UNITED STATES PATENT AND TRADEMARK OFFICE

APPLICATION NO.	FILING DATE	FIRST NAMED INVENTOR	ATTORNEY DOCKET NO.	CONFIRMATION NO.
10/657,938	09/09/2003	James Robert Champion	FOM-139.01	1614

Office Action Summary	Application No. 10/657,938	Applicant(s) CHAMPION ET AL.	
	Examiner Walter Benson	Art Unit 2858

FINAL ACTION

FIG. 3

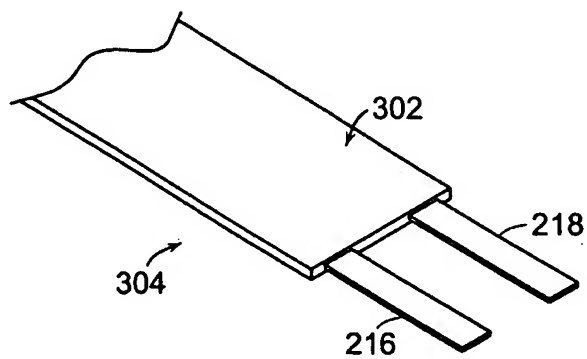
2. Claims 4, 6, 7, 13, 23, 27, 55 and 56 are rejected under 35 U.S.C. 112, first paragraph, as failing to comply with the enablement requirement. The claim(s) contains subject matter, which was not described in the specification in such a way as to enable one skilled in the art to which it pertains, or with which it is most nearly connected, to make and/or use the invention. Applicant claims a first conductive element and a second conductive element, which will reflect a mismatch at the dielectric, mismatch boundary, as depicted in figure 2 and further described as “a parallel conductor transmission line structure “in claim 55. Claim 23 further recite, “driving a first electromagnetic signal along the first conductive element without also driving the second

conductive element". Hence, the first and second conductor, being in physical proximity to each other, without further shielding element disclosed (figure 3) form an approximation to a transmission line with respect to each other. Because of this, a signal applied to one of the conductors will also drive the second conductor. Evidence of this assertion is presented in "the ARRL Handbook for Radio Amateurs", PTO 1449, filed 8/12/05, which presents a model a two conductor transmission line at page 16-1, figure 2. From this figure, it is evident that through capacitive and inductive coupling, each of the two conductors are inextricably linked. Thus, without some undisclosed measures, it is not possible to drive one of the conductors without driving the other.
